Proposed Drawing Amendments

FIG. 5

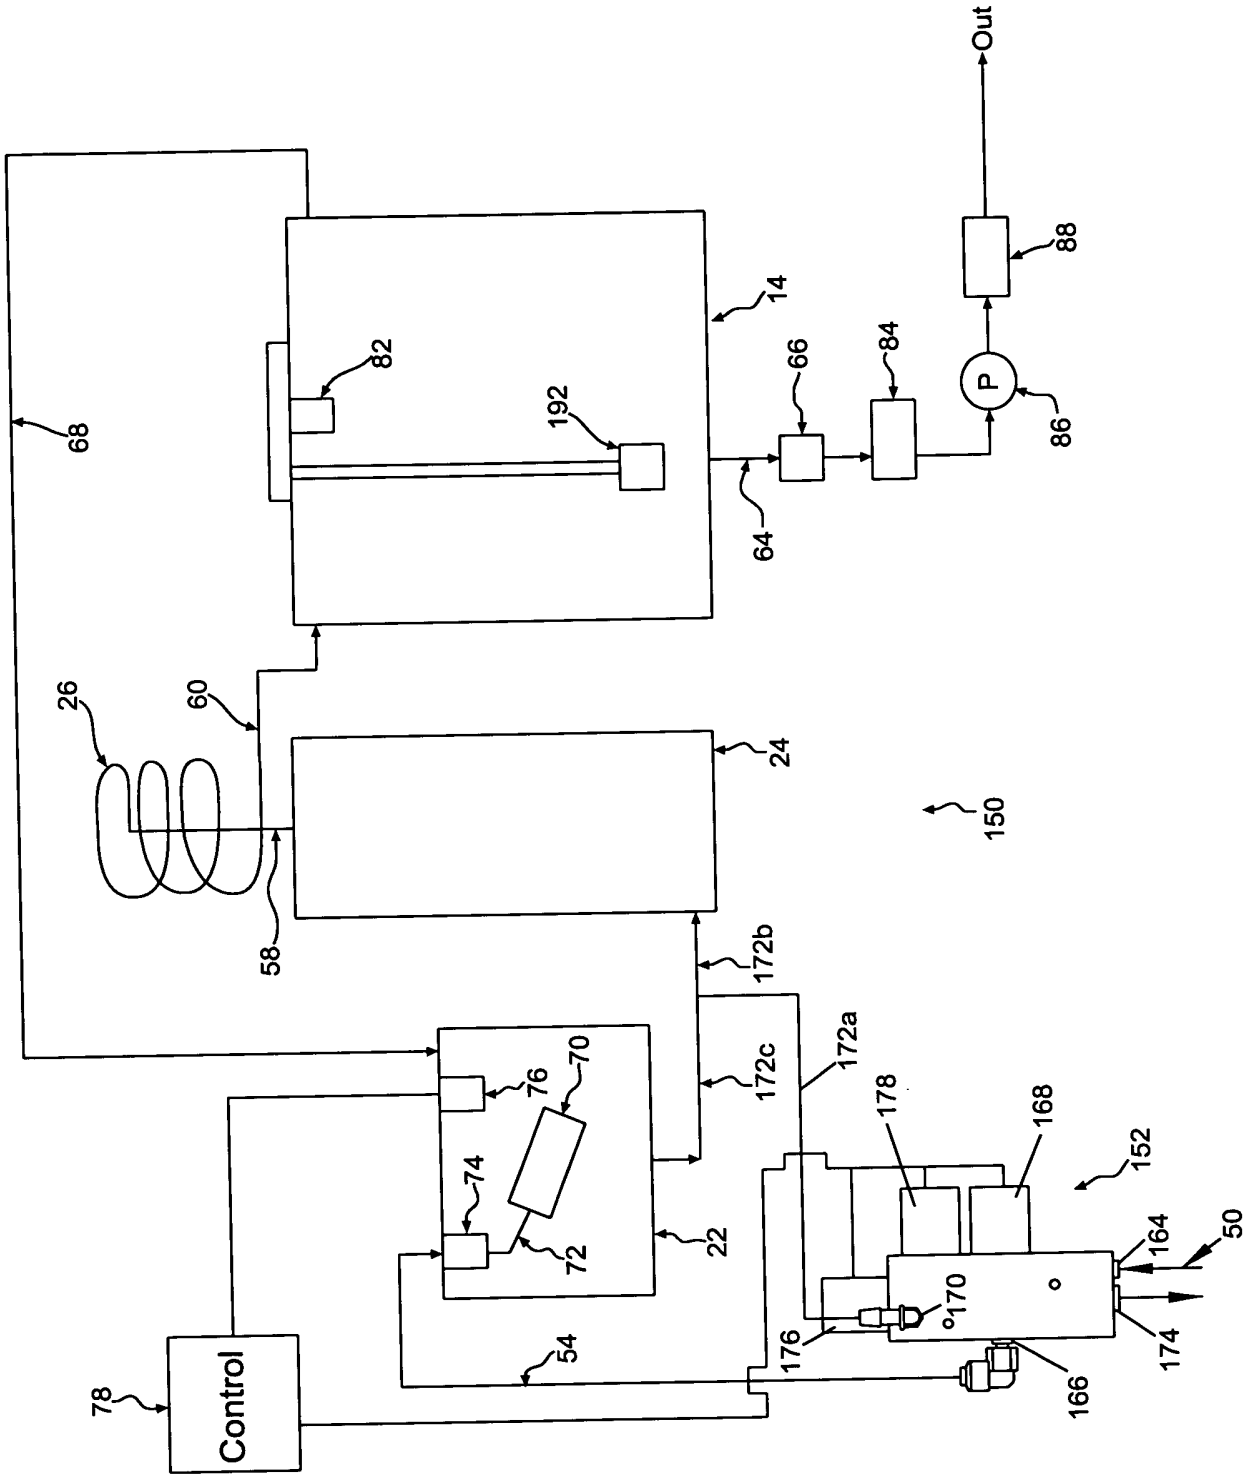
In FIG. 5, element 192, recited in the Specification as a low water float switch, at line 24, page 12, was mislabeled as element 150. A replacement FIG. 5 has been amended to effect this change. No new matter was added to FIG. 5. An Annotated Drawing Sheet is attached herewith the amendment indicated in red. A Replacement Drawing Sheet including FIG. 5 is also attached herewith.
